File Ref: 21/117
 30 June 2022

Subject: Moss Vale Road North URA – Draft DCP
Lot 7 DP 618693 Bells Lane Meroo Meadow

On behalf our client, HDB are submitting the following submission in response to the Moss Vale Road North URA – Draft DCP.

Figure 8: MVRN Draft DCP Local & Retail Street Profile

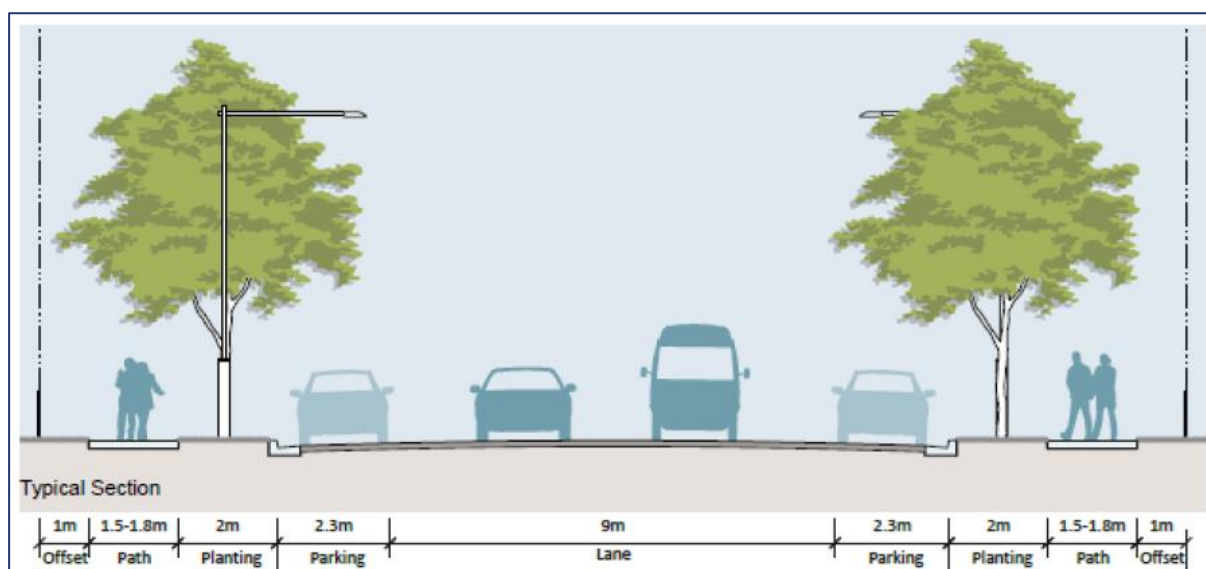
In addition, and as with the Collector Road profile discussed in Section 4.3.1, the Local Street and Retail Street profile in the MVRN Draft DCP appears to provide significantly more traffic carrying capacity than required; this profile is provided as Figure 12 of the MVRN Draft DCP, and is reproduced below.

Figure 9: MVRN URA Roundabout Intersections

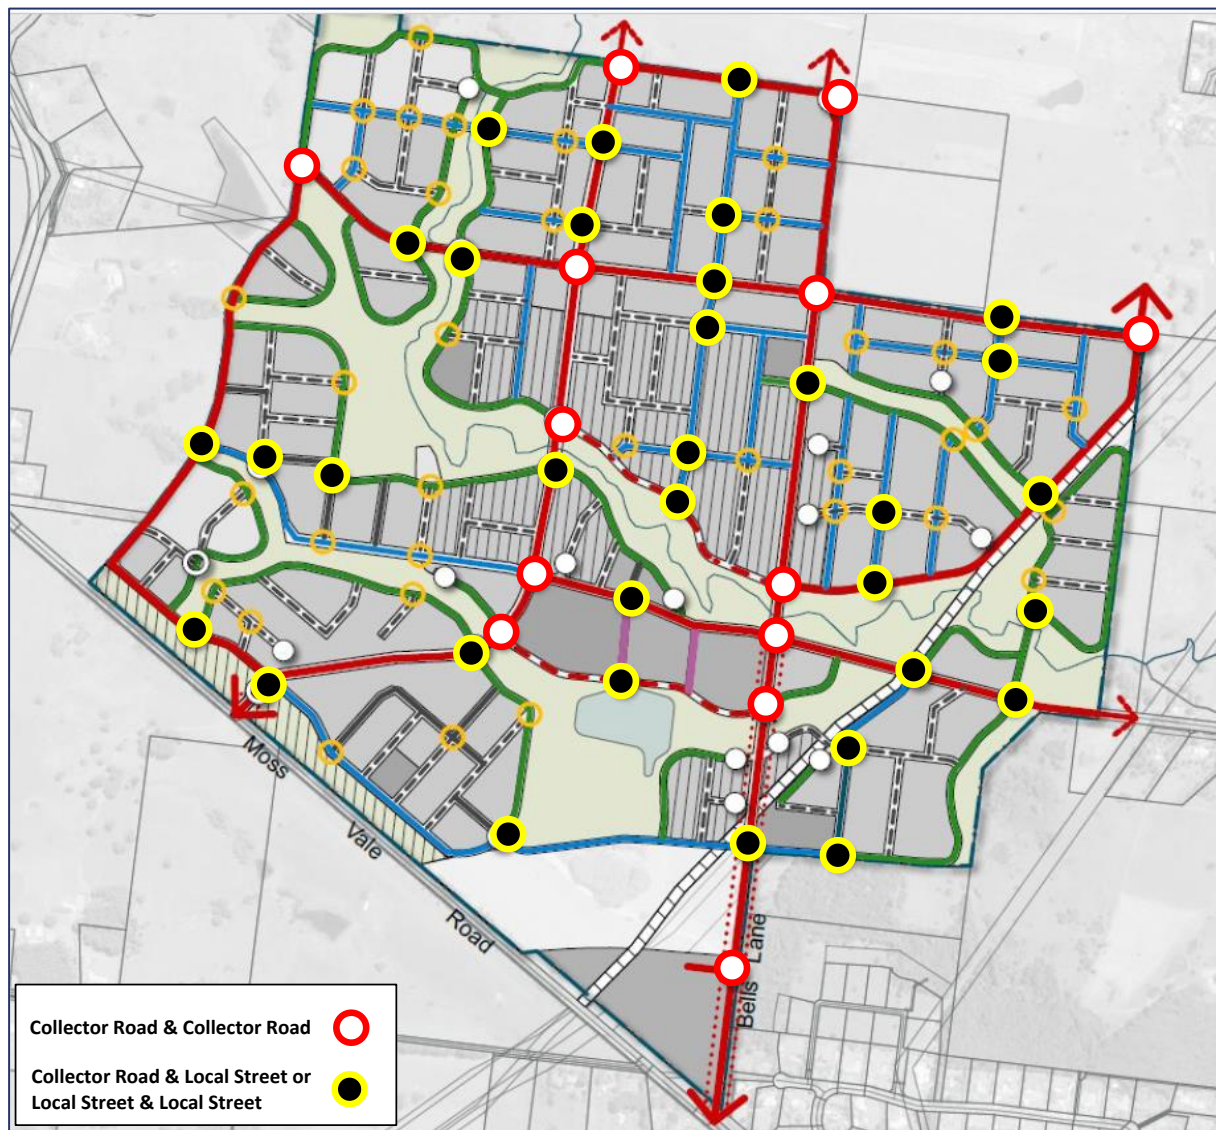
Roundabout intersections of Collector Roads & Local Streets, and of Local Streets & Local Streets, as currently detailed in the MVRN SHNP are shown in Figure 9.

Figure 10: Low Volume Roundabouts

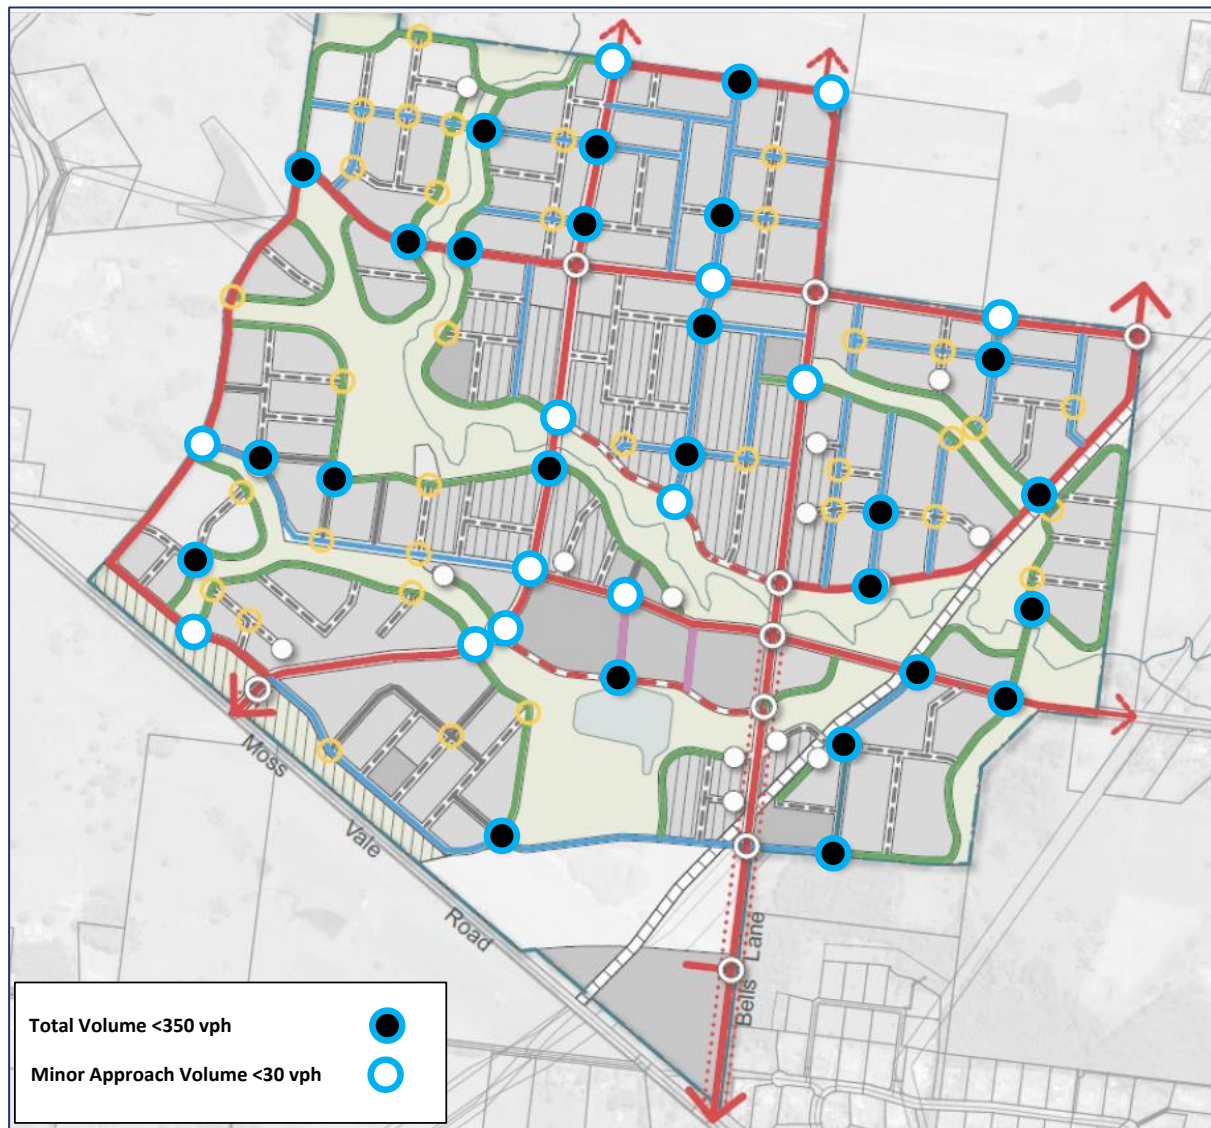
Further to the above, the actual traffic volumes at the majority of the intersections of Collector Roads & Local Streets are very moderate, and have very unbalanced traffic flows; this is (with reference to the MVRN ITS SIDRA outputs) the same at essentially all of the Local Street roundabouts. [Figure 10](#) shows those roundabouts where the total traffic volume at the intersection is less than 350vph, or where the minor approach volume is less than 30vph (i.e. 1 vehicle every 2 minutes).

Figure 18: Recommended Roundabout Locations

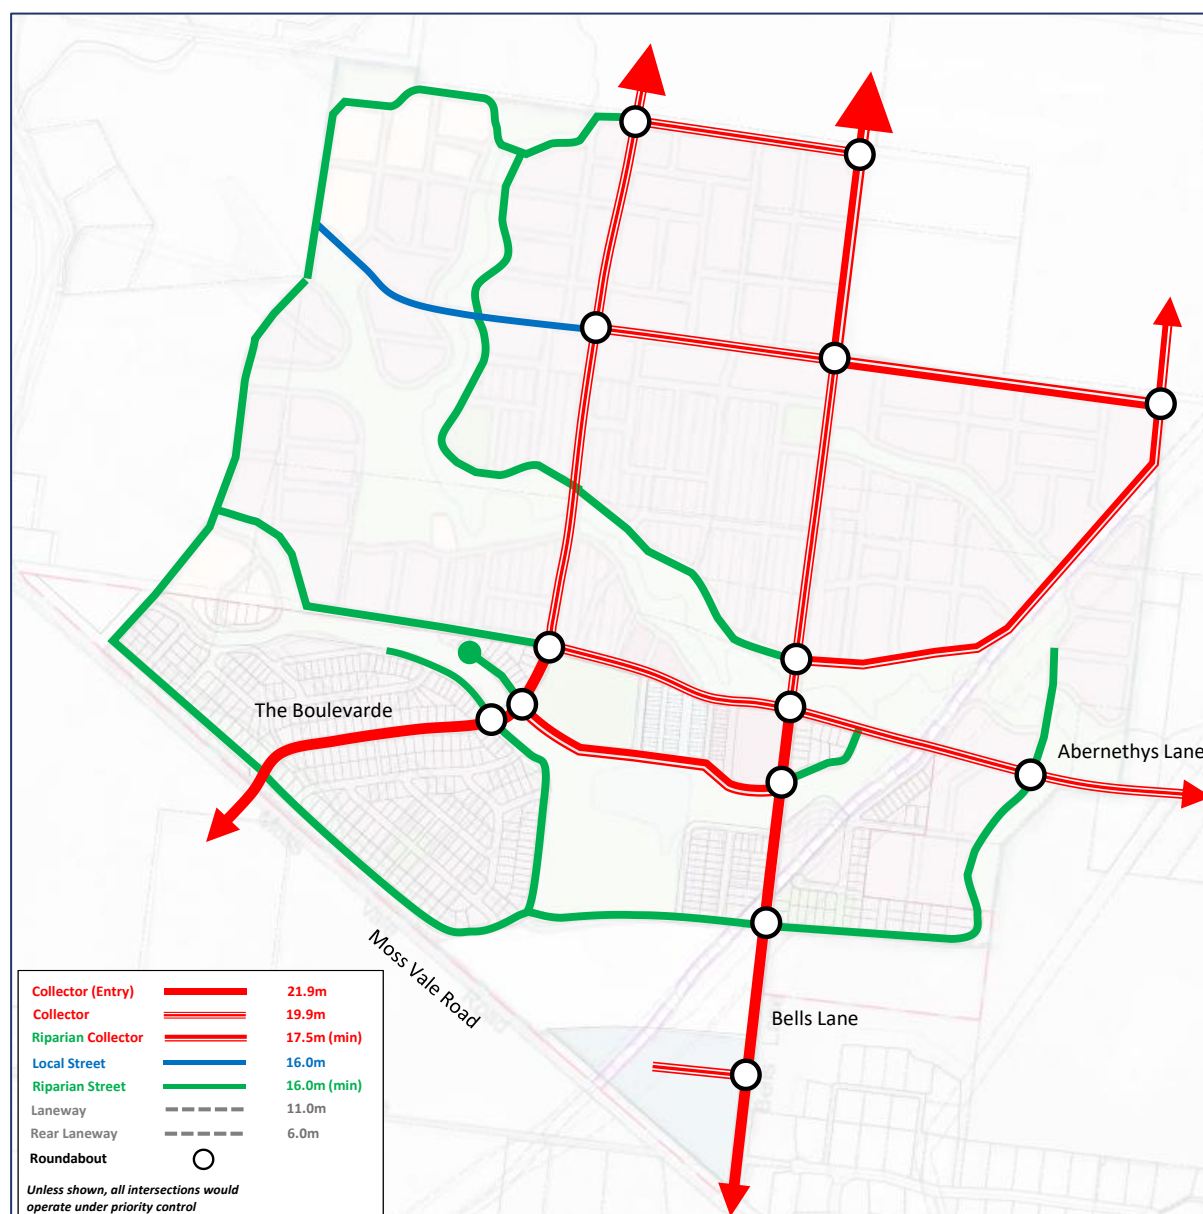
Further to these considerations, [Figure 18](#) shows the [arc traffic + transport](#) recommended roundabout locations within the MRN URA road network.

Figure 19: Northern MVRN URA 4-Way Intersections

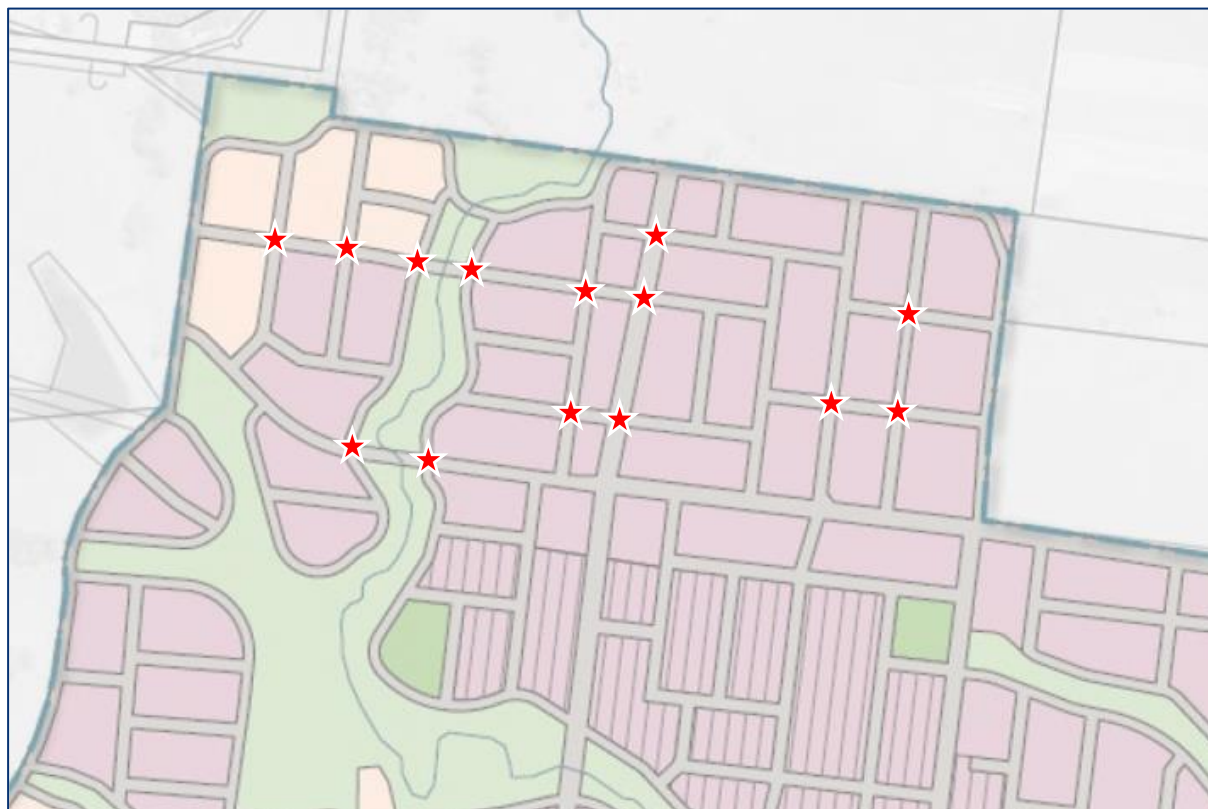
This is particularly the case in the northern part of the MVRN URA, as shown in Figure 19.

4-way intersections with [what will be] very low traffic volumes do not necessarily operate with higher delays or less safety than 3-Way intersections, and as shown in the figures of new residential areas (Figure 14 to Figure 17) 4-Way intersections are used in many instances. However, in the new residential areas shown in these figures, there is a more balanced trip distribution to the north, south, east and west, and as such having more north-south and east-west roads increases general accessibility.

While fixing the location of internal local roads within the broader MVRN URA will of course be dependent on a number of issues - including perhaps most importantly the need to provide certainty for adjacent land holders where local roads extend across multiple land holdings - there is certainly scope to revise these local roads, particularly in the northern parts of the MVRN URA.

Figure 32: Recommended Street Hierarchy and Network Plan

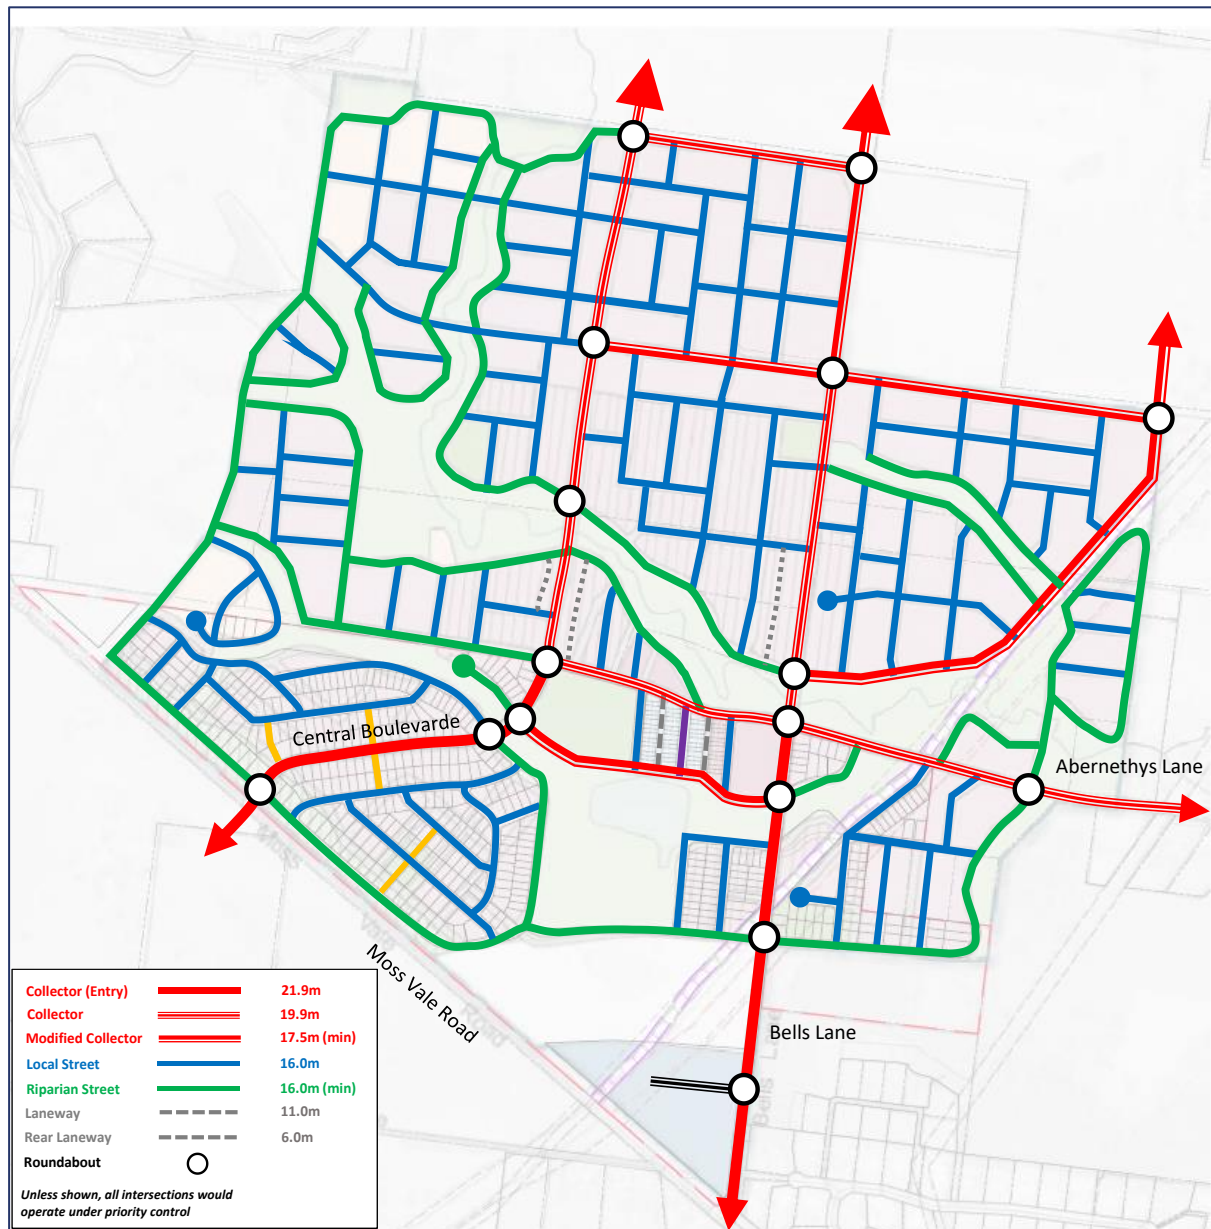
With reference to the assessment of intersection treatments provided in Section 4.4, and the assessment of road profiles provided in Section 5, Figure 32 provides a summary of the recommended road hierarchy and network, which would effectively update the MVRN SHNP provided as Figure 7 of the MVRN Draft DCP.
